Date: 8th May 2026
Reference: R10145-2 Rev 1

Re: Baldock Street, Royston – Planning Condition 18

FIGURE 1 – COMMERCIAL UNIT

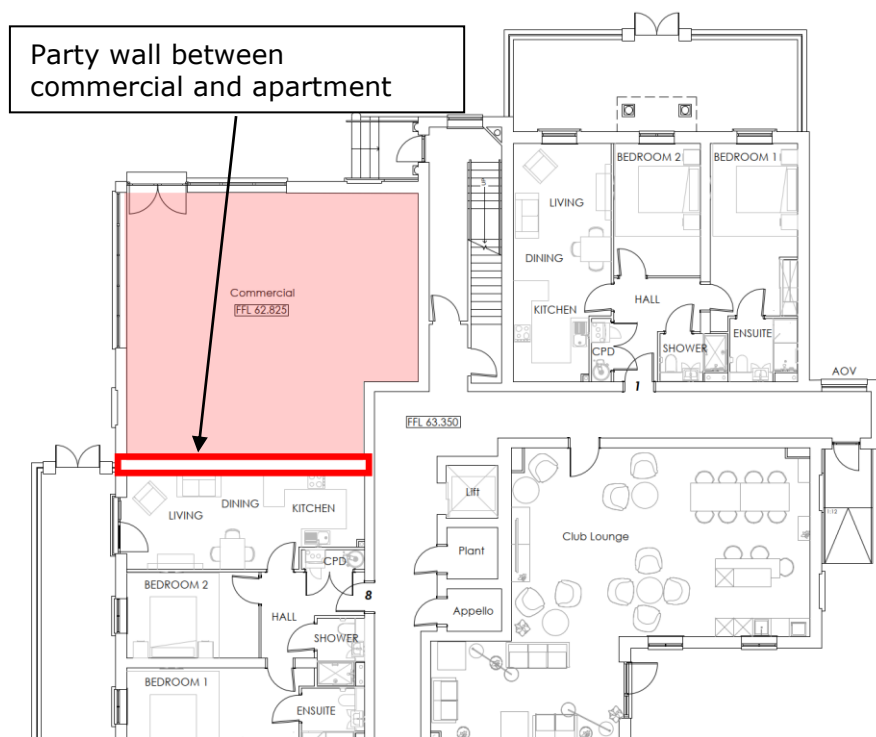
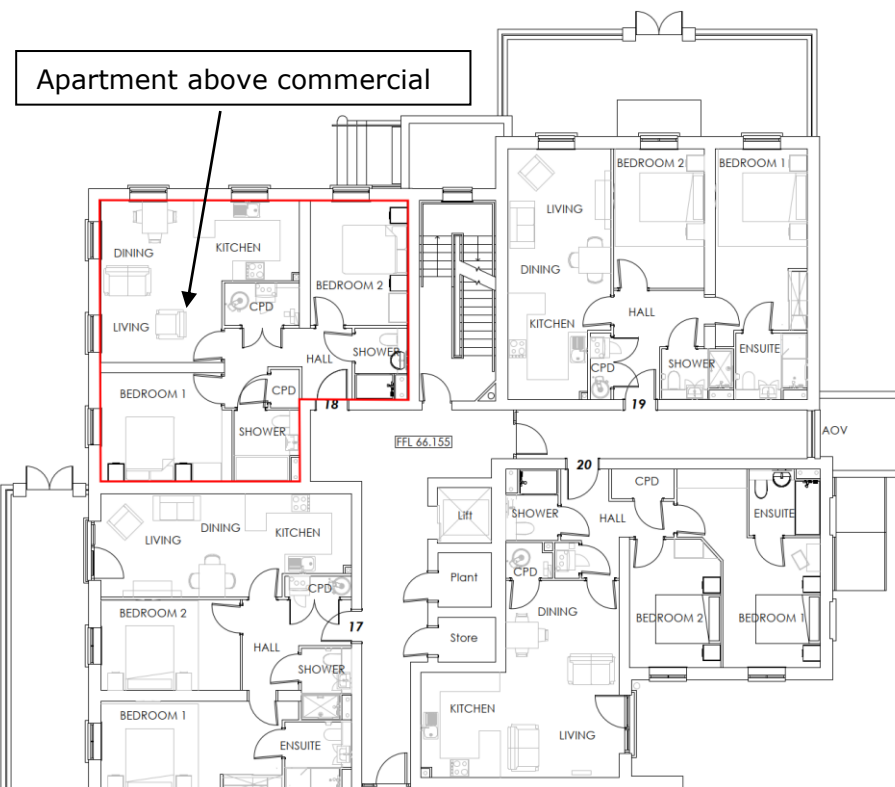
- 2.10 The planning noise assessment recommends that the party floors and party walls separating residential properties from the ground floor commercial unit be specified and built to achieve a minimum sound insulation performance of 55 dB $D_{nT,w} + C_{tr}$, i.e 10 dB better than the minimum Part E requirements.

- 2.11 The location of the commercial unit in relation to the apartments is shown in Figure 1.
- 2.12 The separating floor above the commercial unit will be constructed from screed on rigid insulation on top of precast concrete planks. To achieve the required sound insulation performance, a ceiling shall be provided in the commercial unit as per the below overall construction:

- Minimum 47mm flow screed
 - 55mm rigid insulation
 - 150mm precast concrete planks (minimum mass per unit area 300 kg/m²)
 - Minimum 100mm cavity
 - 50mm mineral wool (minimum 33 kg/m³) laid above the ceiling

- 2 x 12.5mm high density plasterboard (e.g. British Gypsum Soundbloc) installed on acoustic hangers (e.g. British Gypsum GAH1 / GAH2)

2.13 The cavity masonry party wall between the commercial unit and apartment 8 shall include an independent lining on the apartment side of the party wall, as per the below overall construction:

- 100mm concrete blockwork (minimum density 1450 kg/m³)
- 150mm cavity fully filled with Superglass Superwall 32
- 100mm concrete blockwork (minimum density 1450 kg/m³)
- Independent lining on the apartment side, comprising:
 - 2 x 12.5mm high density plasterboard (e.g. BG Soundbloc)
 - Minimum 50mm metal studs, offset from blockwork by at least 10mm
 - 50mm mineral wool (minimum 33 kg/m³) in the cavity

2.14 With good workmanship and favourable flanking conditions, the above party floor and party wall constructions are capable of achieving 55 dB D_{nT,w} + C_{tr} in line with the recommended criterion.
